Enclosure 2 to E-56212

SAR Changed Pages

7.5 Cask Handling Building

Figure 7-56
Cask Handling Building Structural Steel Framing Arrangement, Typical Interior Section (Looking North)

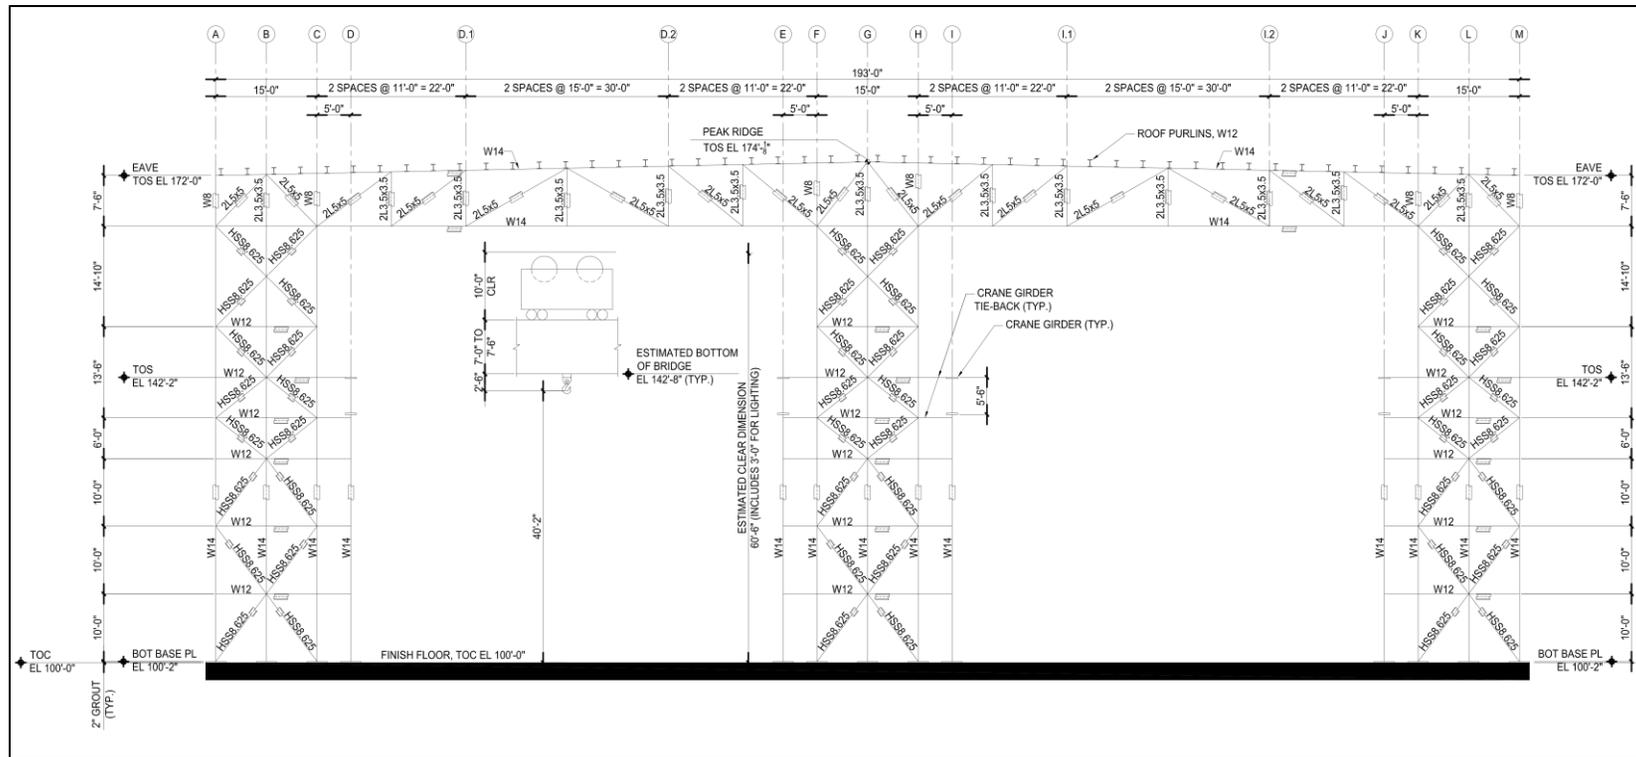
The framing arrangement shown in Figure 7-56 and utilized on all seven east-west column lines provides lateral system redundancy, distributed lateral stiffness with limited torsional irregularity, and sufficient lateral stiffness to meet drift limitations for bridge crane supporting structures. These design objectives are further achieved via the arrangement of the roof bracing system (i.e., diaphragm); see Figures 7-54, 7-60, and 7-61. As shown, the primary east-west roof trusses are laterally supported by the secondary bridging trusses framed along the full north-south length of the building at the two wind column lines in each crane bay (Column lines D.1, D.2, I.1, and I.2; a typical section at line I.2 is shown in Figure 7-60). Horizontal diagonal roof bracing in the planes of the top and bottom chords is then provided between the primary and secondary trusses to create a continuous roof diaphragm that assures system redundancy by distributing lateral loads among the north-south and east-west braced column lines. The continuous roof diaphragm also limits relative drift of individual vertical frames subjected to localized lateral forces imparted by the cranes.

Figure 7-62
Cask Handling Building 3D STAAD.Pro Finite Element Model

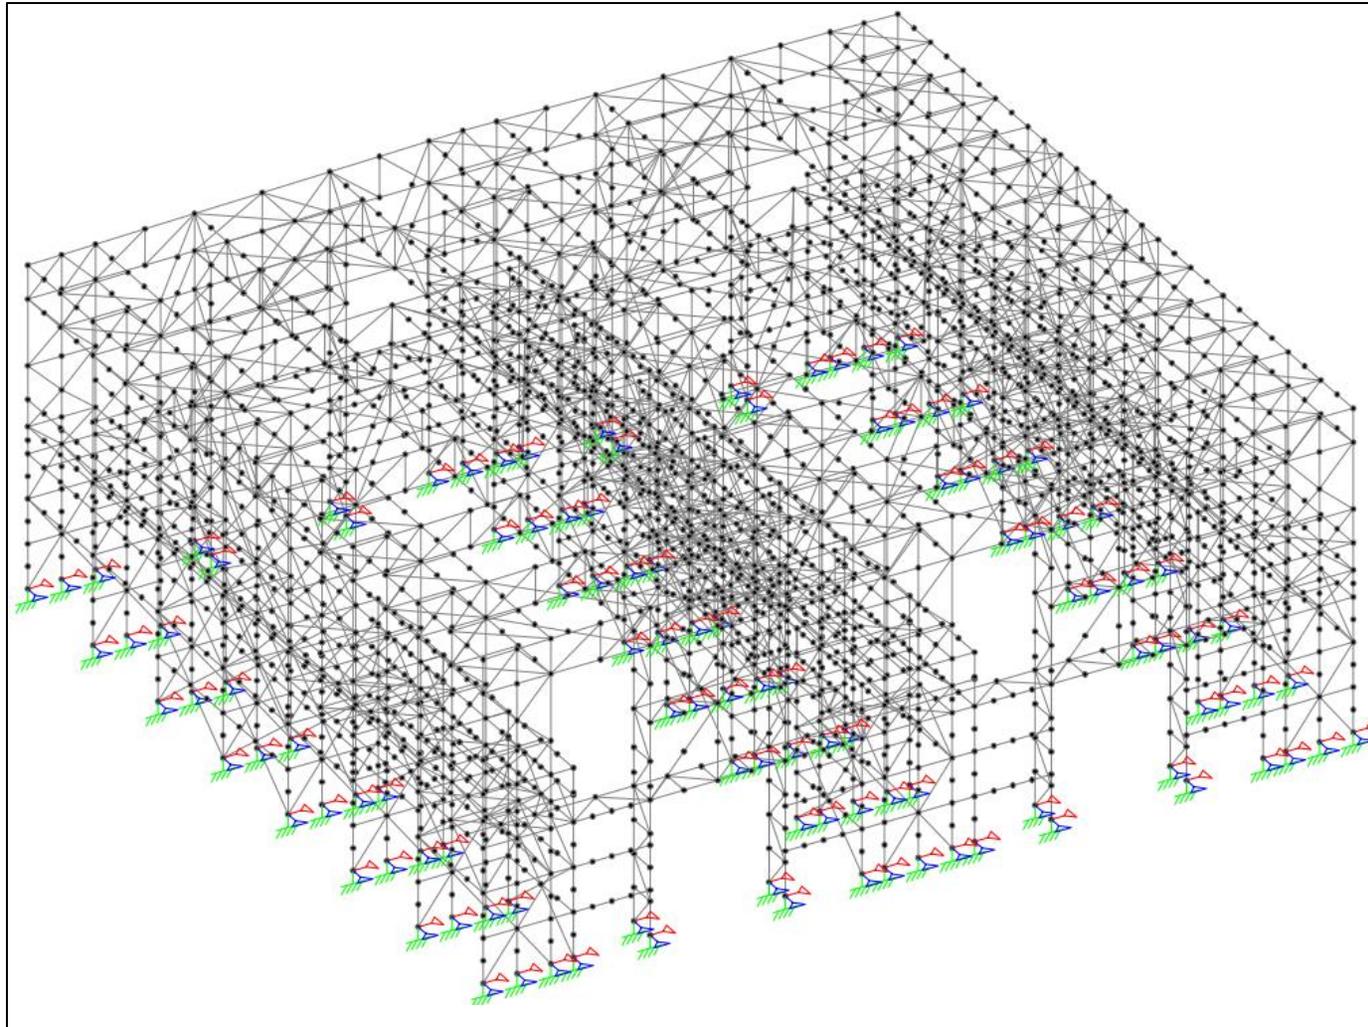
Figure 7-62 shows an isometric view of the three-dimensional finite element analysis model generated in program STAAD.Pro (STAAD). The STAAD version utilized is the CONNECT Edition, Version 22.01.00.38, which is verified and validated under an ASME NQA-1 compliant quality program.

The global coordinate system for the CHB STAAD model is defined with positive X eastward, positive Y upward, and positive Z southward. The global boundary conditions modeled in all static and dynamic loading cases in STAAD consist of pinned supports at the base of each column. Each pinned base restrains the global UX, UY, and UZ translations, as well as ROTY rotations for analysis stability. The pinned base nodes are modeled at the bottom of column base plate elevation. Local boundary conditions applicable to individual members typically involve pinned member end releases (local ROTY and ROTZ) for all beams, vertical braces, and horizontal braces, as well as at the top of columns where they connect to the continuous roof truss chords.

The model includes approximately 3100 nodes and 5800 beam elements, with the intent of sufficient refinement to provide an accurate assessment of structure response to static and dynamic loading. The STAAD beam elements are formulated with six degrees of freedom per node (three translations and three rotations) and with shear deformation effects included in the member stiffness matrix. STAAD utilizes a diagonal, lumped mass matrix approach, with mass terms at all active degrees of freedom. Since dynamic analysis is performed to evaluate the CHB for seismic and tornado missile loading, members with significant transverse loading between points of support (e.g., beams and girders) are subdivided into multiple beam elements to capture dynamic flexural responses while utilizing the STAAD lumped mass formulation. At a minimum, three intermediate nodes (four elements) are used for all beams and girders.
